**ENGINEERING HALL SPRINKLER AND GAS PIPING – PHASE 2  
UNIVERSITY OF WISCONSIN - MADISON  
MADISON, WISCONSIN**

**ADDENDUM #4**

UWSA Project No. **A-23-003**

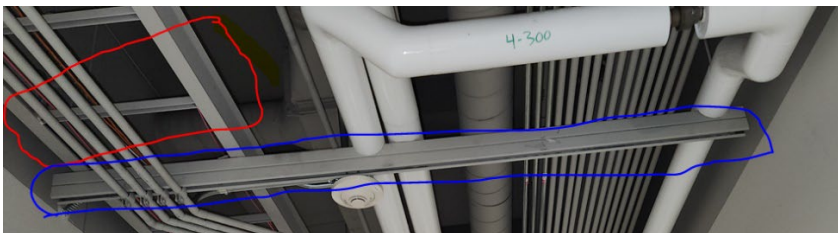
2. Referring to the image below, are the full hall width struts authorized support points?  
**Response: For bidding purposes the electrical contractor shall assume that these struts will be able to support new conduit runs. The exact location of all struts is not included on the design documents and areas may exist where additional new conduits supports will be required as described in specification section 26 05 33 Raceway and Boxes for Electrical Systems, Part 3 Execution.**
